PRELIMINARY/FINAL DRAINAGE REPORT

CROSSROADS MIXED USE FILING NO. 2 EL PASO COUNTY, COLORADO

NOVEMBER 2022

EPC's EDARP File
Number: SF2238
(with no dashes or
extras zeros or extra
spaces in the file
number)

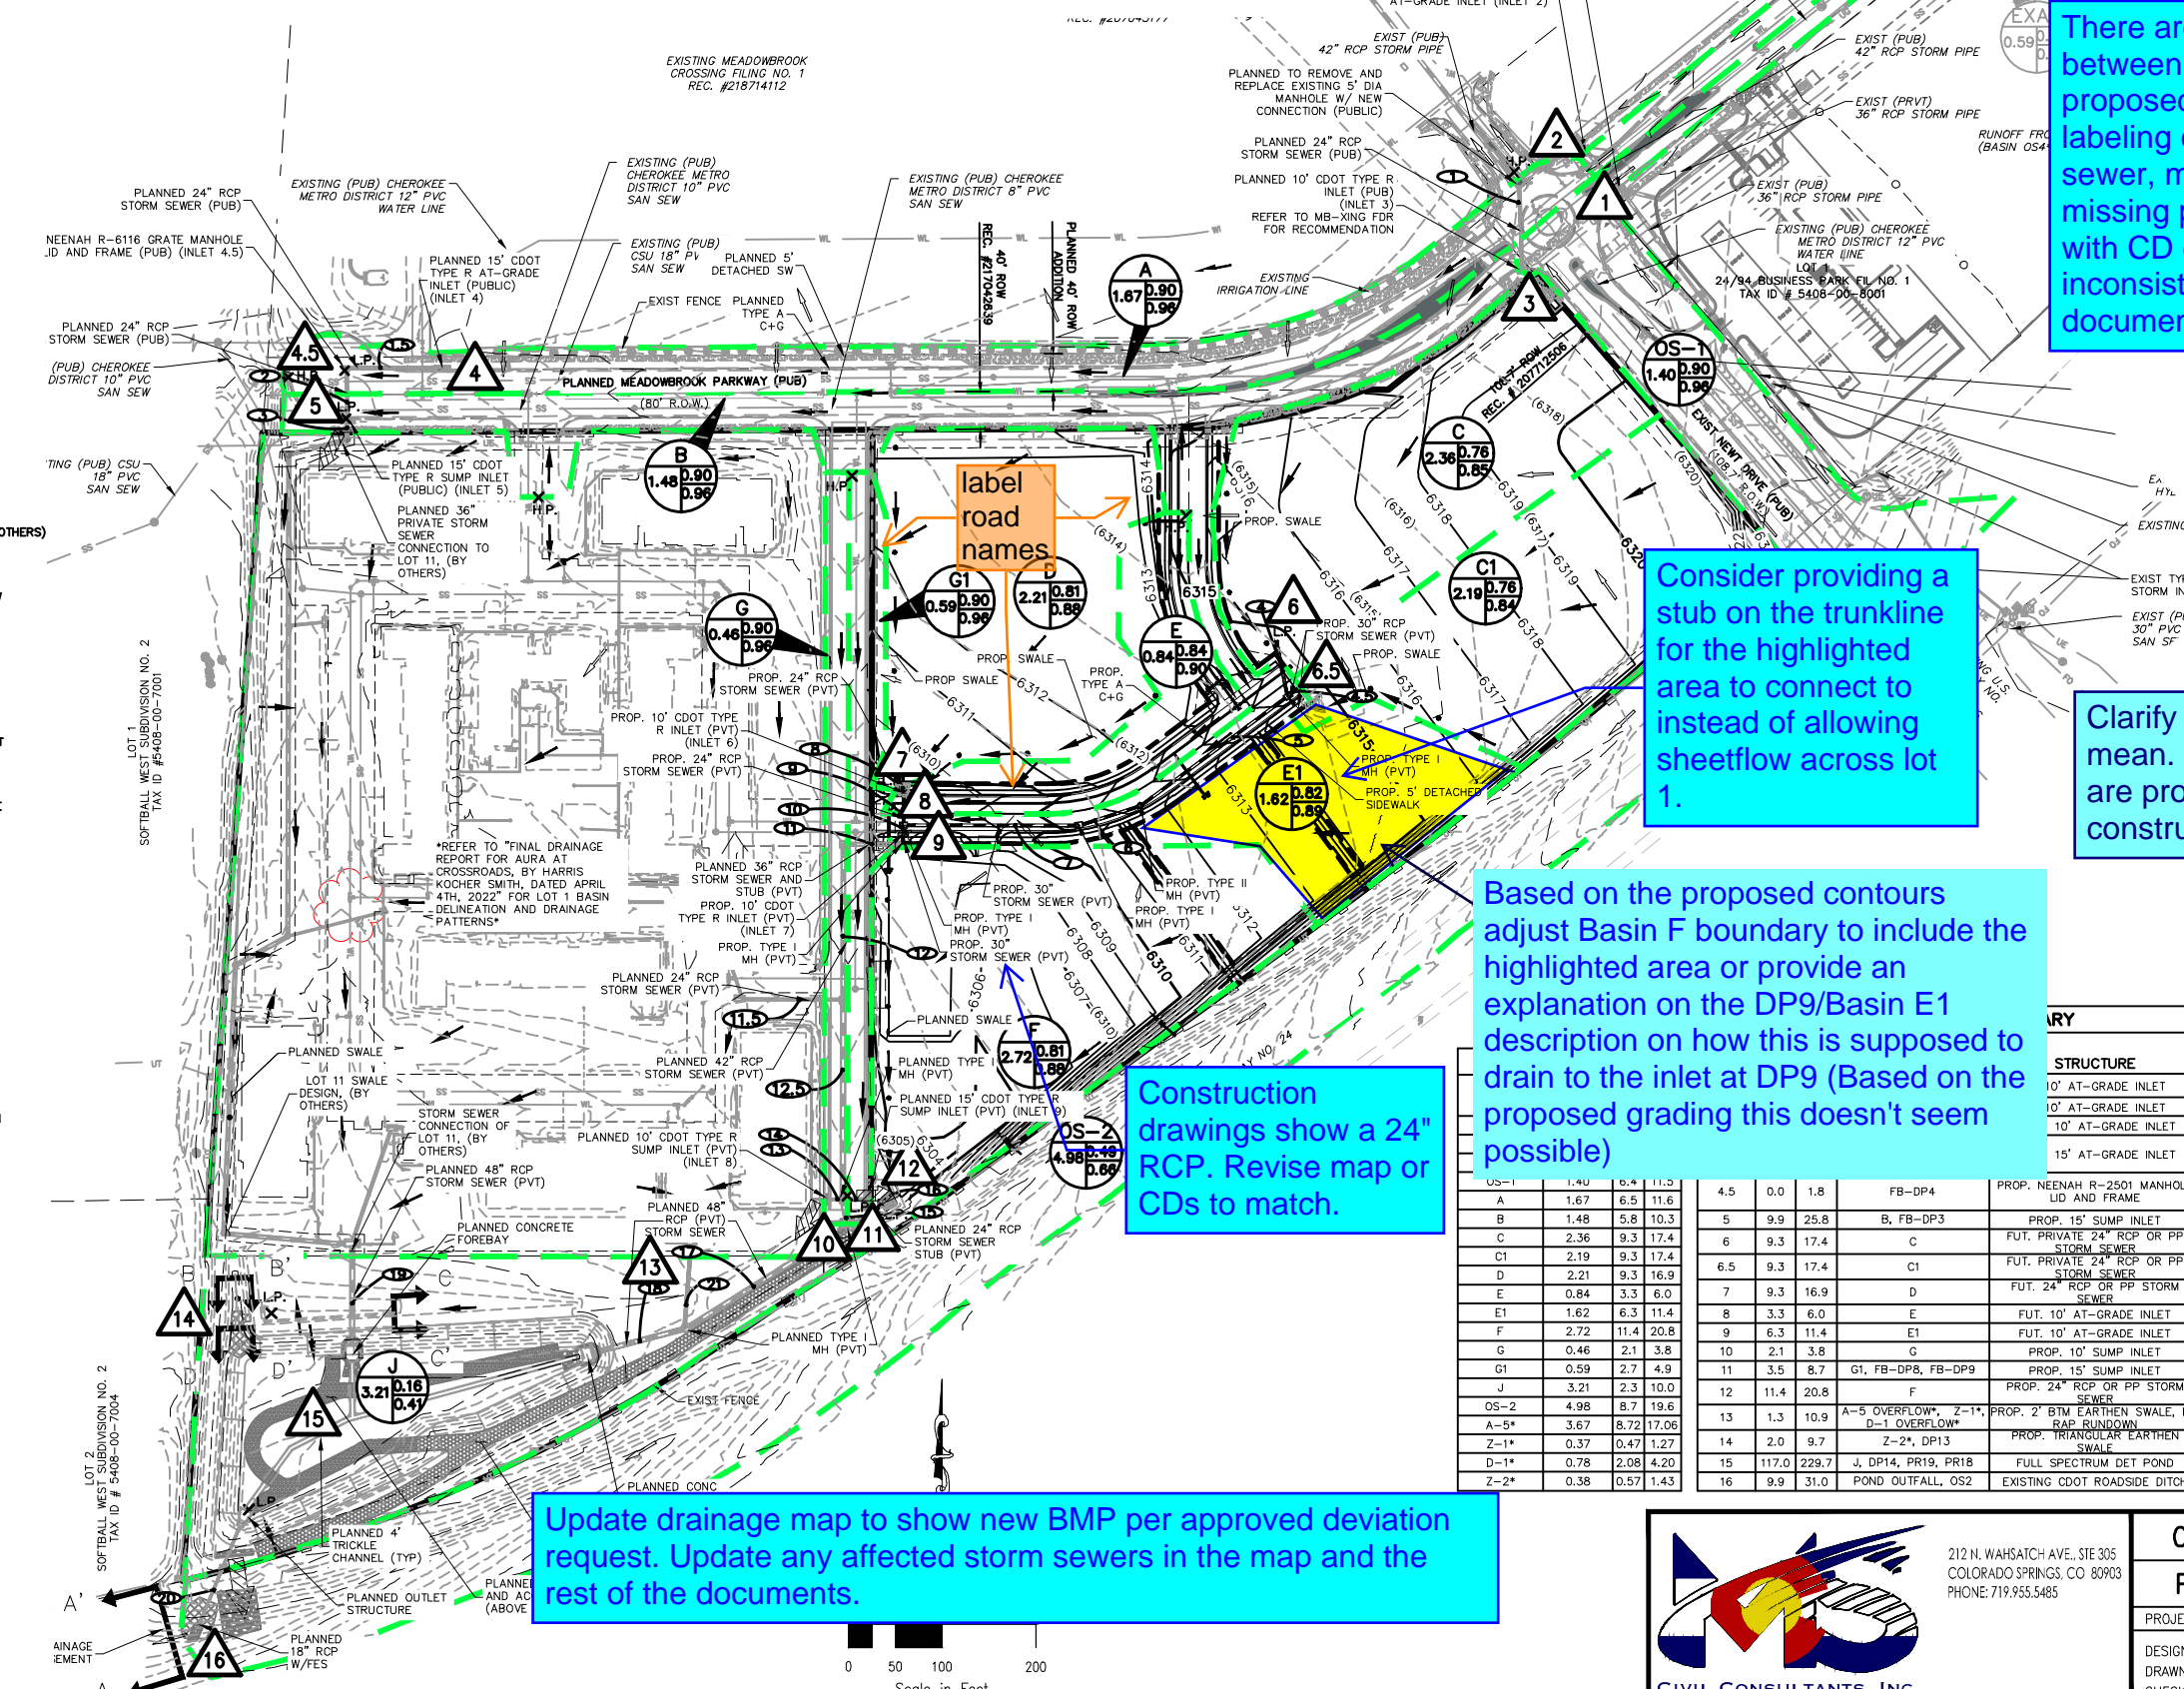
There are several inconsistencies between these drainage map and CDs proposed conditions. These include: labeling of private and public storm sewer, mismatched pipe sizes, and missing proposed swales. Coordinate with CD engineer to remove inconsistencies between the two documents.

Clarify what "planned" improvements mean. Staff is assuming "Planned" are proposed improvements constructed with filing 1.

Based on the proposed contours adjust Basin F boundary to include the highlighted area or provide an explanation on the DP9/Basin E1 description on how this is supposed to drain to the inlet at DP9 (Based on the proposed grading this doesn't seem possible)

Construction drawings show a 24" RCP. Revise map or CDs to match.

Update drainage map to show new BMP per approved deviation request. Update any affected storm sewers in the map and the rest of the documents.
